# Access Compliance Report

## Public Rights-of-Way

### (Curb Ramps)

Intersection ID: 51750	Main Street: GOLF_LINKS_DR_N	Cross Street: ALLISON_WOODS_DR	Location: SW
ADA ID: 537CB4ED0FA9	Ramp Type: Perp	Initial Pass/Fail: Fail	Overall Compliance: No
Severity Score: 25			
Codes/Mitigation Info/Possible Solution		Field Measurements/Component Compliance

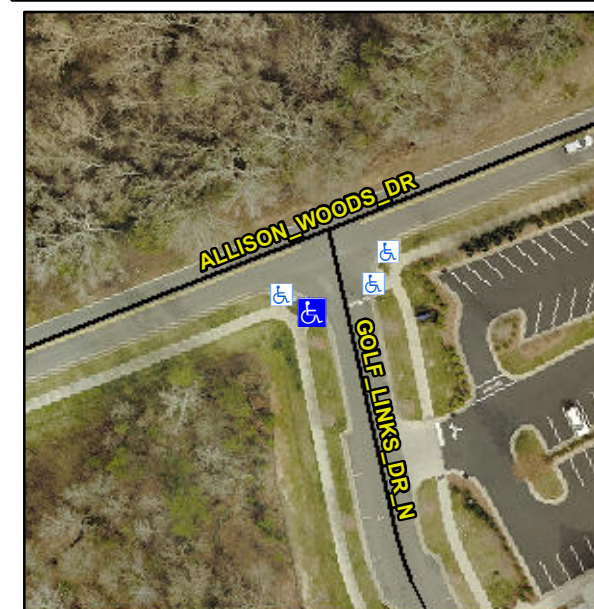
**R304.2.2, R304.5.3**

Compliance	Description	Data	Compliance	Description	Data
N/A	Ramp Length (in)	78.0	No	Ramp Slope (%)	11.5
Yes	Ramp Width (in)	48.0	No	Ramp XSlope (%)	5.1
N/A	Flare Type LT	N/A	N/A	Flare Type RT	N/A
N/A	Flare Slope LT (%)	N/A	N/A	Flare Slope RT (%)	N/A
N/A	Flare Traversable LT?	N/A	N/A	Flare Traversable RT?	N/A
N/A	Landing Length (in)	N/A	N/A	DWS Provided?	N/A
N/A	Landing Width (in)	N/A	N/A	DWS Contrast?	N/A
N/A	Landing Slope (%)	N/A	N/A	DWS Length (in)	N/A
N/A	Landing X Slope (%)	N/A	N/A	DWS Full Width?	N/A
N/A	Landing Curb? (Y/N)	N/A	N/A	DWS Offset (in)	N/A
N/A	Shared Landing?	N/A			
N/A	Gutter Ponding?	N/A	N/A	Gutter Slope (%)	N/A
N/A	Gutter Lip Ht (in)	N/A	N/A	Gutter X Slope (%)	N/A
N/A	Painted X Walk1?	No	N/A	Painted X Walk2?	N/A
	X Walk 1 Direction	To NE		X Walk 2 Direction	N/A
N/A	X Walk 1 Width (in)	N/A	N/A	X Walk 2 Width (in)	N/A
	X Walk 1 Slope (%)	3.5		X Walk 2 Slope (%)	N/A
	X Walk 1 X Slope (%)	4.2		X Walk 2 X Slope (%)	N/A

**Remove & Replace Entire Ramp.**
